# 100% CONSTRUCTION DOCUMENTS

## WOODMEN HILLS WASTEWATER STORAGE FACILITY

### TRACT K MERIDIAN RANCH FIL 1, EL PASO COUNTY, STATE OF COLORADO

Comments are provided on the CDs for informational purposes only. CDs are not required for this project because the disturbance is under an acre and because of the scope of work proposed. No resubmission request will be sent for the CD package. See comment on page 6 regarding the sheets that sheets that are not a part of the CD submittal.

<b>WOODMEN HILLS WASTEWATER</b>			
WOOMEN HILLS METRO 100% CONSTRUCTION DOCUMENTS			
<b>OVERALL SITE PLAN</b>			
DESIGNED BY: MDF	SCALE: 1" = 50'	DATE ISSUED: JUNE 2025	DRAWING No. SP01
DRAWN BY: MDF	HORIZ: N/A	SHEET: 3 OF 8	
CHECKED BY: MDF	VERT: N/A

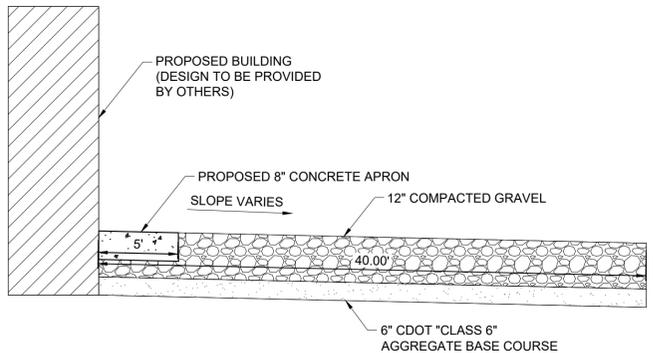
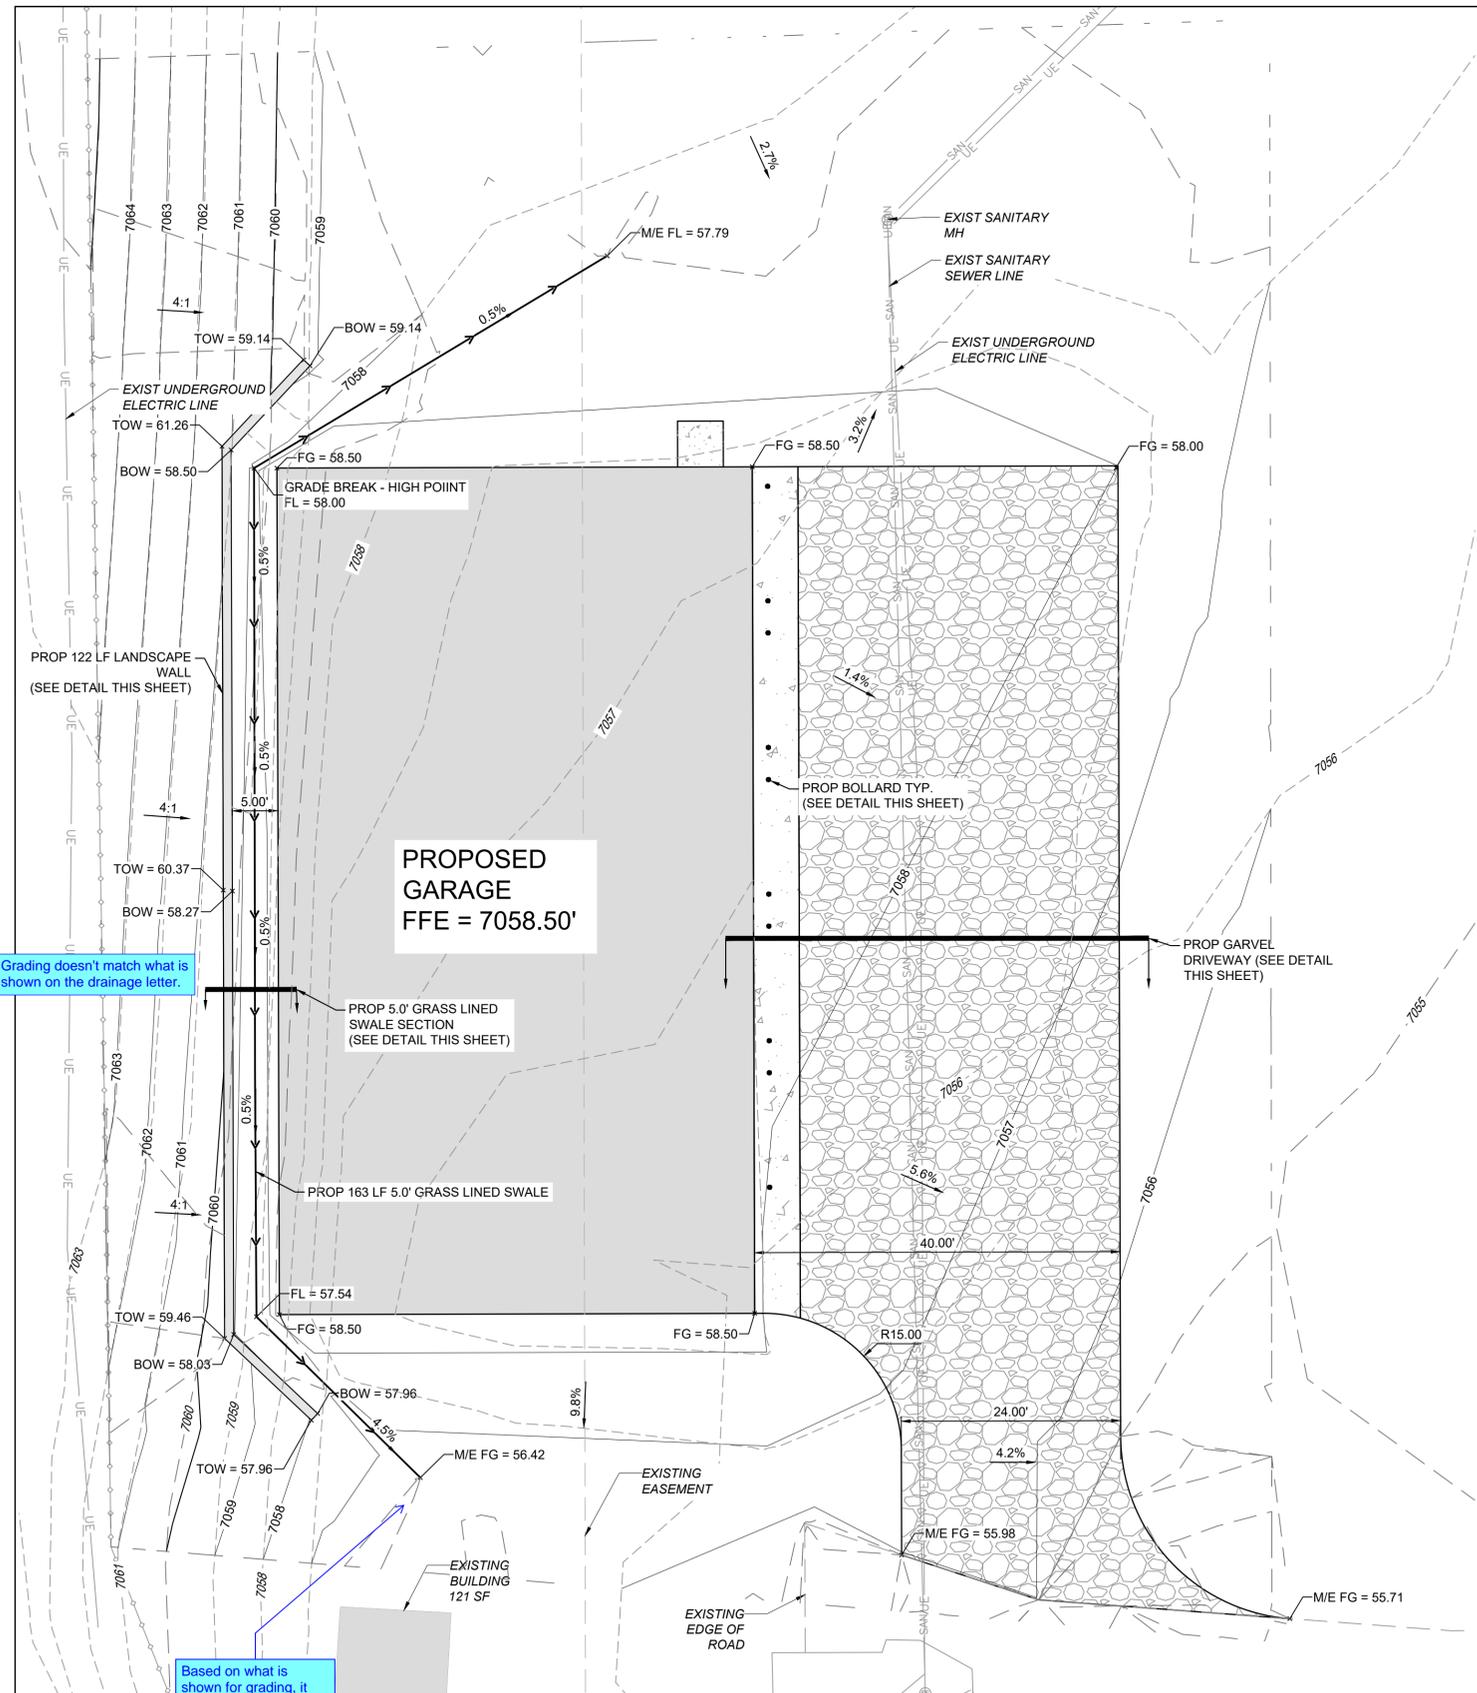
the radii will not accommodate the Falcon Fire apparatus  
Per Falcon Fire's uploaded letter this road shall be no less than 20' width

08041C0551G,  
typical all sheets.

WOODMEN HILLS WASTEWATER WOOMEN HILLS METRO 100% CONSTRUCTION DOCUMENTS DETAIL GRADING PLAN

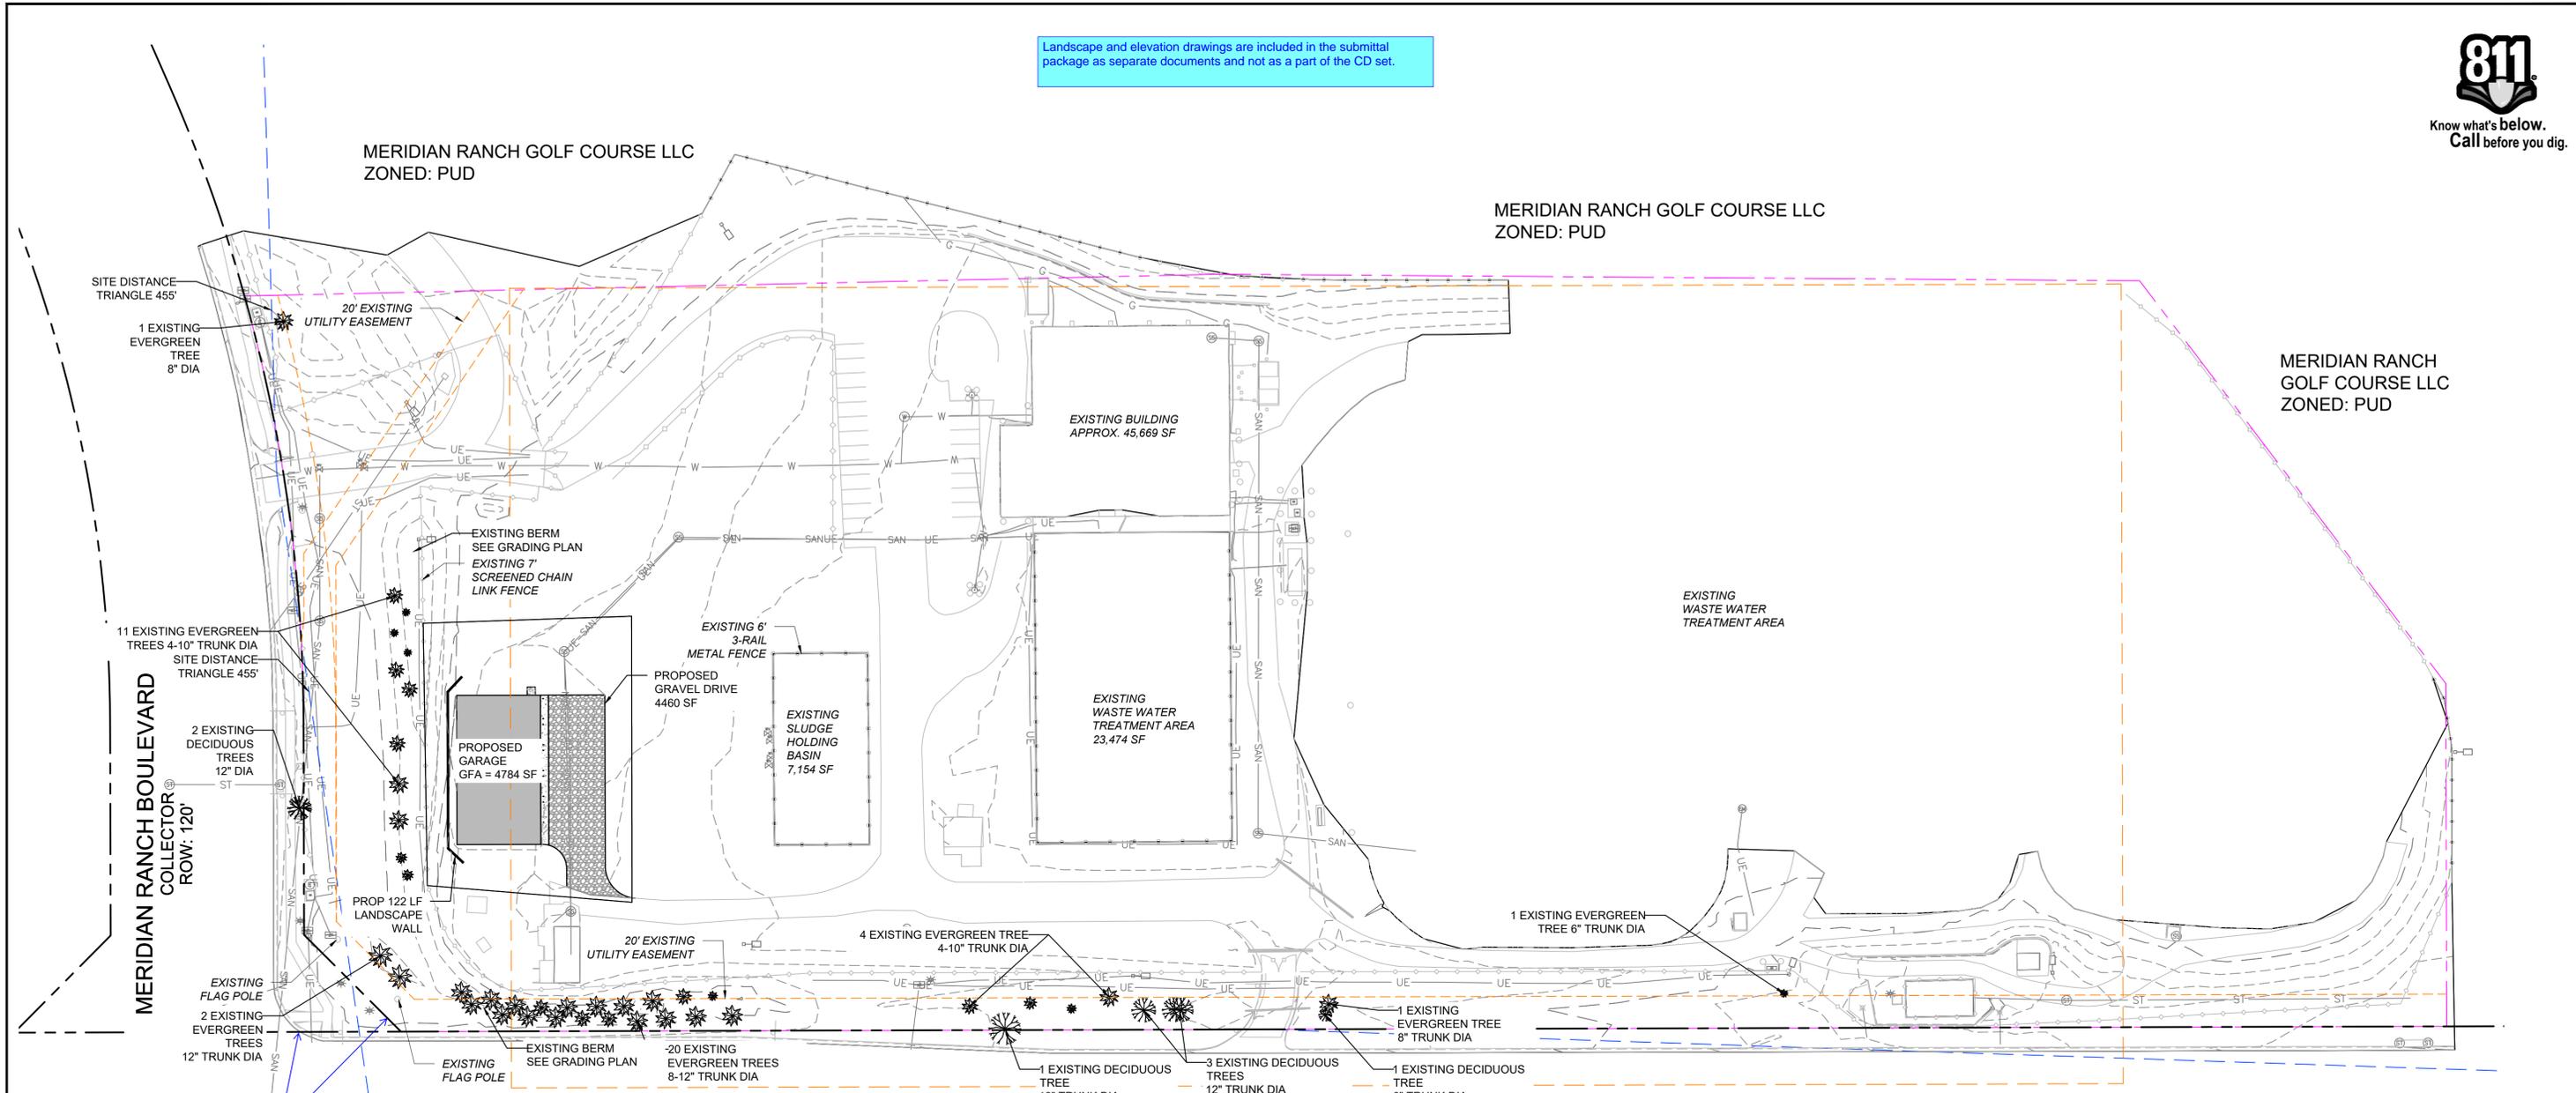
Grading doesn't match what is shown on the drainage letter.

Based on what is shown for grading, it appears that the grading may be directing this flow to the south of the site instead of to the east.
